Corrigendum to “Interdependencies between physical, design and operational parameters for direct use geothermal heat in faulted hydrothermal reservoirs” [Geothermics, 86 (2020) 101806](S0375650519303785)(10.1016/j.geothermics.2020.101806)

Corrigendum to “Interdependencies between physical, design and operational parameters for direct use geothermal heat in faulted hydrothermal reservoirs” [Geothermics, 86 (2020) 101806]

Figure 9 Published.

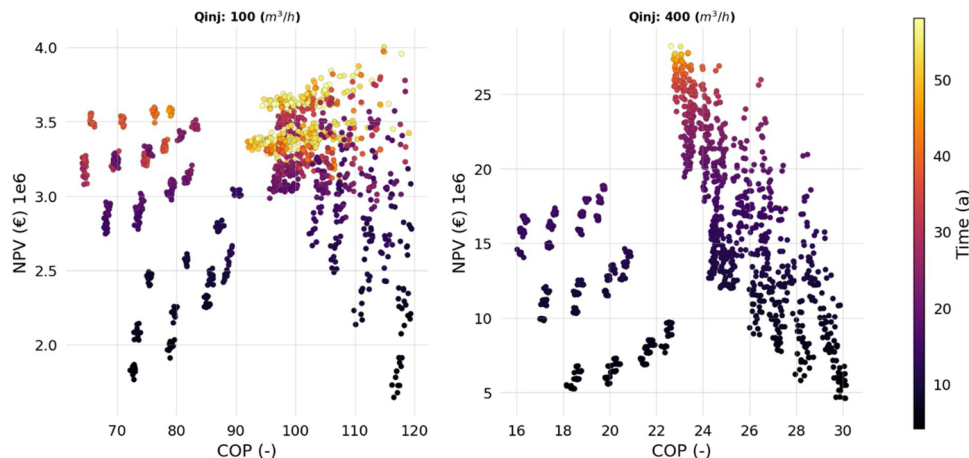
This was not done for the published data, due to different versions of the code being used. As a result, the time value of money was discounted much more than it should be (7% each 100 days when it should be 1.8697% per 100 days), leading to lower NPV values. This affects section 3.3 “Lifetime and NPV” of the published article (Figures 9, 10 and 11). We have re-performed the processing after having addressed this issue and plotted the corrected data in the updated figures below. While the qualitative conclusions that were drawn from the published figures are not significantly different from the corrected ones, the quantitative NPV values of the corrected figures differ substantially.
